Access Audit Site Report

Mustang Island State Park
9394 TX-361
Corpus Christi, TX 78418
Accessibility Evaluation
Inspection Date: 06/13/2022
Inspectors: Tanya Scheibe

Prepared By
WT Group

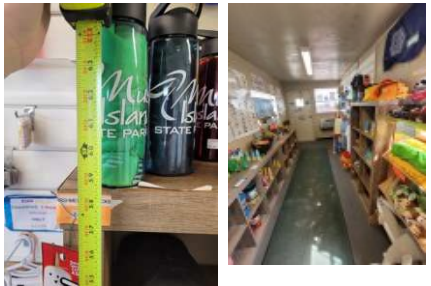
Finding Number	Area Description	Lat/Long	Finding	As Built	Recommendation	Citation	Photos	Figure
9	Exterior: Exterior Accessible Route	[27.6730412 , -97.17323]	The accessible route of travel contains cross slopes greater than 2%. Cross slopes shall not exceed one unit vertical in 48 units horizontal (2-percent slope).	3.3% slope by men's chase, 3% at turn to men's chase by bike rack	Correct or repair cross slope along AR to max 2.08%.	2015 ABAAS Section: 403.3 2012 TAS Section: 403.3 2010 ADAS Section: 403.3		
10	Exterior: Exterior Accessible Route	[27.6731469 , -97.173368 2]	There is a gap spaced greater than a 1/2 inch. Openings in floor or ground surfaces shall not allow passage of a sphere more than 1/2 inch diameter. Elongated openings shall be placed so that the long dimension is perpendicular to the dominant direction of travel.	5" gap on path to restrooms from electric sites	Correct or fill gaps to be max .5".	2015 ABAAS Section: 302.3 2012 TAS Section: 302.3 2010 ADAS Section: 302.3

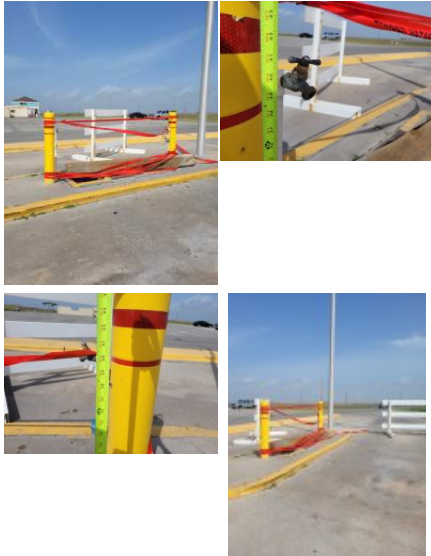
Finding Number	Area Description	Lat/Long	Finding	As Built	Recommendation	Citation	Photos	Figure
17	Headquarters (HQ) : HQ - Employee Spaces	[27.6733773 , -97.174945 3]	Spaces and elements within employee work areas shall only be required to comply with 206.2.8, 207.1, and 215.3 and shall be designed and constructed so that individuals with disabilities can approach, enter, and exit the employee work area. Employee work areas, or portions of employee work areas, other than raised courtroom stations, that are less than 300 square feet (28 m2) and elevated 7 inches (180 mm) or more above the finish floor or ground where the elevation is essential to the function of the space shall not be required to comply with these requirements or to be on an accessible route.	maintenance says this booth is temporary and that they plan to build new one - knob, 7.5" change in level	Repair, bevel, or ramp CILs at door entries to max .25". Replace hardware with lever hardware or hardware operable without a tight pinch or grasp. In the alternative, leave as is until replaced.	2015 ABAAS Section: F203.9 2012 TAS Section: 203.9 2010 ADAS Section: 203.9

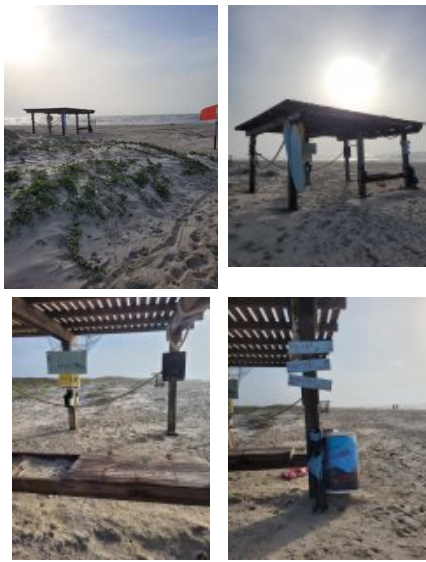
Finding Number	Area Description	Lat/Long	Finding	As Built	Recommendation	Citation	Photos	Figure
23	Headquarters (HQ) : HQ - Portable Restroom	[27.6722502 , -97.174941 3]	The portable public restroom is not compliant. 5% of portable toilets must be accessible, minimum of 1. If sanitary facilities are provided, they must be made accessible to persons with disabilities. If public restrooms are desired, It is recommended that the portable unit be replaced with a permanent built in compliant restroom. The utilization of an accessible portable unit may be a temporary solution and is not recommended as a permanent solution.	Portable restroom at HQ not of accessible design (1 of 1 in area)	Replace 5% of portable toilets with compliant models and place along AR	2015 ABAAS Section: F213.1 2012 TAS Section: 213.1 2010 ADAS Section: 213.1, 213.2 Exception 3		
24	Headquarters (HQ) : HQ - Portable Restroom	[27.6733239 , -97.174889]	The portable public restroom is not compliant. 5% of portable toilets must be accessible, minimum of 1. If sanitary facilities are provided, they must be made accessible to persons with disabilities. If public restrooms are desired, It is recommended that the portable unit be replaced with a permanent built in compliant restroom. The utilization of an accessible portable unit may be a temporary solution and is not recommended as a permanent solution.	Portable toilet at entry booth - portable toilet not of accessible design	Replace 5% of portable toilets with compliant models and place along AR	2015 ABAAS Section: F213.1 2012 TAS Section: 213.1 2010 ADAS Section: 213.1, 213.2 Exception 3

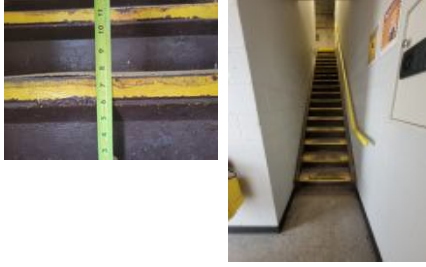
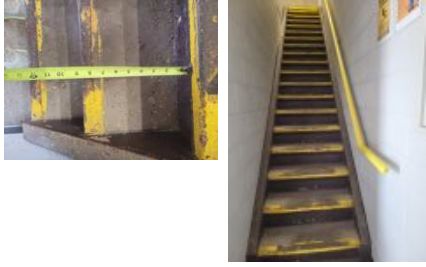
Finding Number	Area Description	Lat/Long	Finding	As Built	Recommendation	Citation	Photos	Figure
40	Park Site: Campsites	[27.6732396 , -97.1730892]	An accessible access route is not provided between elements, spaces and the facilities provided within the accessible camping unit. At least one outdoor recreation access route shall connect accessible elements, spaces and facilities provided within camping units with mobility features.	electric sample site 25 - amenities do not connect	Create AR with crushed and compacted stone or similar outdoor material to camp sites and one of each type of amenity.	2015 ABAAS Section: F244.5.1		
41	Park Site: Campsites	[27.6731493 , -97.1731134]	Picnic tables shall provide at least one wheelchair space for each 24 linear feet (7320 mm) of usable table surface perimeter. Wheelchair spaces shall be 30 inches (760 mm) minimum by 48 inches (1220 mm) minimum. Wheelchair spaces shall be positioned for a forward approach to the table and provide knee and toe clearance complying with 306 under the table	sample site 25 - 11" toe clearance	Replace picnic table with one of an accessible design as a smart practice	2015 ABAAS Section: 1011.4.2

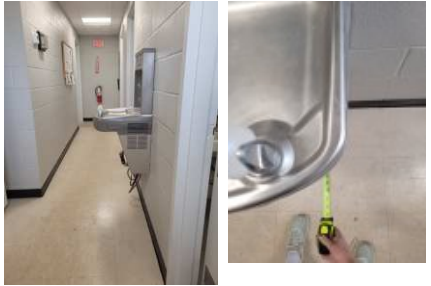
Finding Number	Area Description	Lat/Long	Finding	As Built	Recommendation	Citation	Photos	Figure
46	Park Site: Campsites	[27.672344, -97.173546 5]	Camping facilities shall provide camping units with mobility features complying with F244.2 in accordance with Table F244.2. Where a camping facility provides different types of camping units, Table F244.2 shall apply to each type of camping unit provided. Total Number of Camping Units Provided in Camping Facility Minimum Number of Camping Units with Mobility Features Required 1 1 2 to 25 2 26 to 50 3 51 to 75 4 76 to 100 5 101 to 150 7 151 to 200 8 201 and over 8, plus 2 percent of the number over 200	0 of 4 park host sites are designated accessible but each has paved surfaces and could be more easily made accessible than other campsites.	Create the required number of accessible camp sites per table F244.2 as a smart practice	2015 ABAAS Section: F244.2

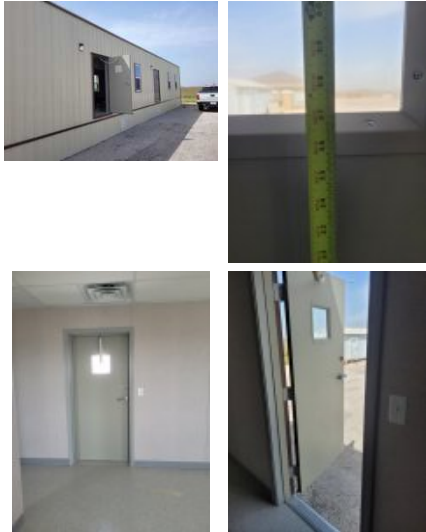
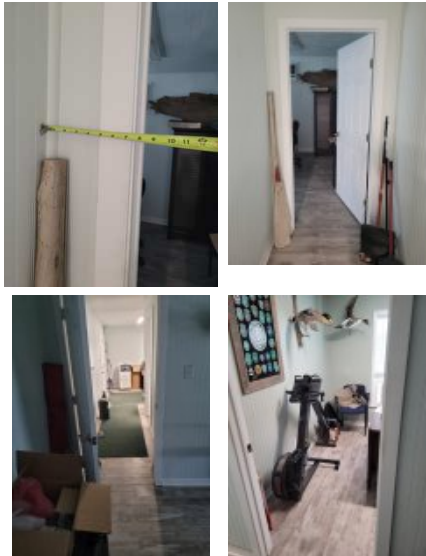
Finding Number	Area Description	Lat/Long	Finding	As Built	Recommendation	Citation	Photos	Figure
48	Park Site: Maintenance	[27.6708309 , -97.1745859]	Spaces and elements within employee work areas shall only be required to comply with 206.2.8, 207.1, and 215.3 and shall be designed and constructed so that individuals with disabilities can approach, enter, and exit the employee work area. Employee work areas, or portions of employee work areas, other than raised courtroom stations, that are less than 300 square feet (28 m2) and elevated 7 inches (180 mm) or more above the finish floor or ground where the elevation is essential to the function of the space shall not be required to comply with these requirements or to be on an accessible route.	main maintenance - 5" change in level, excessive force required due to sticking, 3.5" change in level at garage stall	Repair, bevel, or ramp CILs at door entries to max .25". Inspect, adjust, and maintain 8.5 lbf to open exterior doors as a smart practice.	2015 ABAAS Section: F203.9 2012 TAS Section: 203.9 2010 ADAS Section: 203.9

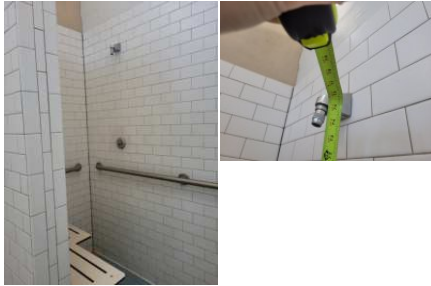
Finding Number	Area Description	Lat/Long	Finding	As Built	Recommendation	Citation	Photos	Figure
55	Park Site: Maintenance	[27.6708261 , -97.174575 2]	An item or items project more than 4 inches into the circulation path. Wall-mounted objects that have leading edges between 27 inches and 80 inches from the floor must not project more than 4 inches into the circulation path. Protruding objects that extend to the floor or within 27 inches of the floor are cane detectable and are therefore not hazardous. Where it is necessary or desirable to have objects protrude from the wall, a manner of cane detection must be provided.	2nd floor - fountain projects 15" into way	Relocate protruding objects or place cane detectable warning or bollard at foot of item.	2015 ABAAS Section: 307.2 2012 TAS Section: 307.2 2010 ADAS Section: 307.2		
56	Park Site: Maintenance	[27.6708214 , -97.174564 4]	Spaces and elements within employee work areas shall only be required to comply with 206.2.8, 207.1, and 215.3 and shall be designed and constructed so that individuals with disabilities can approach, enter, and exit the employee work area. Employee work areas, or portions of employee work areas, other than raised courtroom stations, that are less than 300 square feet (28 m2) and elevated 7 inches (180 mm) or more above the finish floor or ground where the elevation is essential to the function of the space shall not be required to comply with these requirements or to be on an accessible route.	2nd floor - 2 of 2 empty offices have knobs, door further from fountain - shelf in pull side clearance	For employee spaces, relocate storage, furniture, and other obstacles at doorways to provide approach, enter and exit at the employee space. Provide required maneuvering clearance on push and pull side of doors. Replace hardware with lever hardware or hardware operable without a tight pinch or grasp.	2015 ABAAS Section: F203.9 2012 TAS Section: 203.9 2010 ADAS Section: 203.9

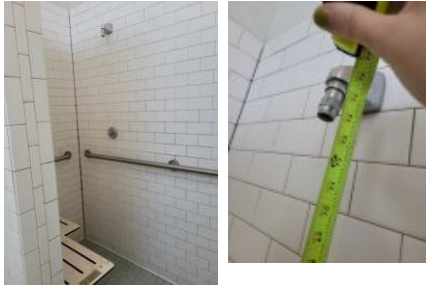
Finding Number	Area Description	Lat/Long	Finding	As Built	Recommendation	Citation	Photos	Figure
68	Restrooms: Men's Restroom	[27.672926, -97.173277]	The shower seat does not have a compliant space between it and the wall. The folding seat must be mounted 17-19 inches above the floor, and have a maximum space of 1-1/2 inches between the edge of the seat and the side wall and 2-1/2 inches maximum to the seat wall.	mounted 2" from side wall	Remount shower seat to the correct location and height in the shower.	2015 ABAAS Section: 610.3.2 2012 TAS Section: 610.3.2 2010 ADAS Section: 610.3.2		
69	Restrooms: Men's Restroom	[27.672945, -97.173234 1]	Element meets all standards and requirements	both men's restroom doors comply	None	2010 ADAS Section: N/A

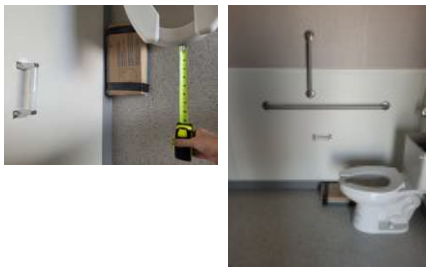
Finding Number	Area Description	Lat/Long	Finding	As Built	Recommendation	Citation	Photos	Figure
84	Restrooms: H1 - Accessible Portable Restroom	[27.6730495 , -97.1732877]	Where a high forward reach is over an obstruction, the clear floor space shall extend beneath the element for a distance not less than the required reach depth over the obstruction. The high forward reach shall be 48 inches (1220 mm) maximum where the reach depth is 20 inches (510 mm) maximum. Where the reach depth exceeds 20 inches (510 mm), the high forward reach shall be 44 inches (1120 mm) maximum and the reach depth shall be 25 inches (635 mm) maximum. Where a clear floor or ground space allows a parallel approach to an element and the high side reach is over an obstruction, the height of the obstruction shall be 34 inches (865 mm) maximum and the depth of the obstruction shall be 24 inches (610 mm) maximum. The high side reach shall be 48 inches (1220 mm) maximum for a reach depth of 10 inches (255 mm) maximum. Where the reach depth exceeds 10 inches (255 mm), the high side reach shall be 46 inches (1170 mm) maximum for a reach depth of 24 inches (610 mm) maximum.	sanitizer 50" above finished floor	Lower operating mechanisms to max 48" above the finished floor (AFF) to highest operable part.	2015 ABAAS Section: 308.2.1, 308.3.2 2012 TAS Section: 308.2.1, 308.3.2 2010 ADAS Section: 308.2.1, 308.3.2

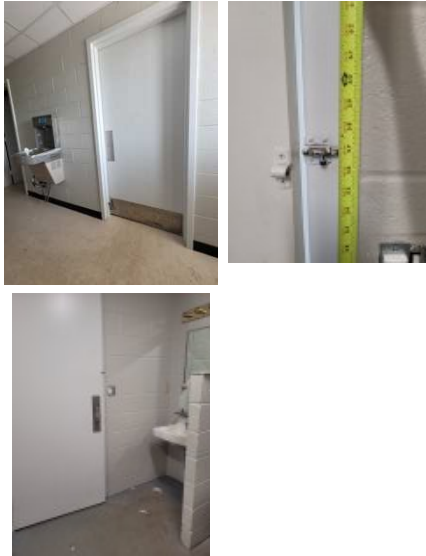
Finding Number	Area Description	Lat/Long	Finding	As Built	Recommendation	Citation	Photos	Figure
91	Restrooms: H1A - Accessible Restroom	[27.673021, -97.173277]	Door openings shall provide a clear width of 32 inches (815 mm) minimum. Clear openings of doorways with swinging doors shall be measured between the face of the door and the stop, with the door open 90 degrees. Openings more than 24 inches (610 mm) deep shall provide a clear opening of 36 inches (915 mm) minimum. There shall be no projections into the required clear opening width lower than 34 inches (865 mm) above the finish floor or ground. Projections into the clear opening width between 34 inches (865 mm) and 80 inches (2030 mm) above the finish floor or ground shall not exceed 4 inches (100 mm). The threshold has a vertical change greater than 1/4 inch high. Hand-activated door opening hardware, handles, pulls, latches, locks, and other operating devices on accessible doors shall have a shape that is easy to grasp with one hand and does not require tight grasping, tight pinching or twisting of the wrist to operate. Hardware shall be 34 inches minimum and 48 inches maximum above the finish floor or ground.	curve starts at 79" AFF, .75" CIL	For all doors along the public circulation route, replace doors with doors having 80" overhead clearance and 32" clear width. For all doors along the public circulation route, repair, bevel, or ramp CILs at door entries to max .25". See previous finding for replacement of unit.	2010 ADAS Section: 404.2.3, 404.2.7, 404.2.4, 404.2.11, 404.2.11 Exception

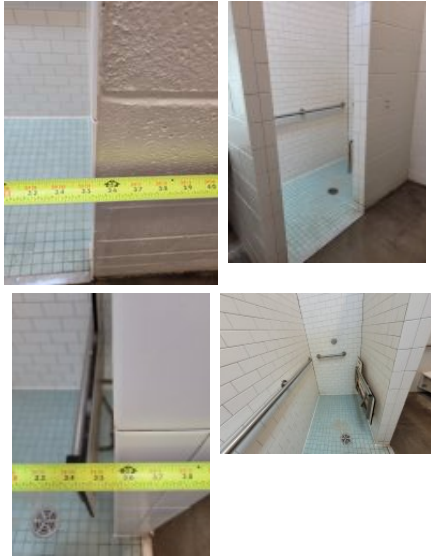
Finding Number	Area Description	Lat/Long	Finding	As Built	Recommendation	Citation	Photos	Figure
101	Restrooms: 2nd Floor Of Maintenance Building Restroom	[27.6708261 , -97.174585 9]	This restroom is not accessible. Where existing toilet rooms or bathing rooms do not comply, directional signs indicating the location of the nearest accessible toilet room or bathing room within the facility shall be provided. Signs shall include the International Symbol of Accessibility. Where existing toilet rooms or bathing rooms do comply), the accessible toilet rooms or bathing rooms shall be identified by the International Symbol of Where clustered single user toilet rooms or bathing facilities are permitted, accessible toilet rooms or bathing facilities shall be identified by the International Symbol of Accessibility unless all toilet rooms and bathing facilities are accessible.	no directional signage at inaccessible restroom	Restroom not accessible, acquire and mount signage directing patrons to accessible restroom.	2015 ABAAS Section: F216.8 2012 TAS Section: 216.8 2010 ADAS Section: 216.8
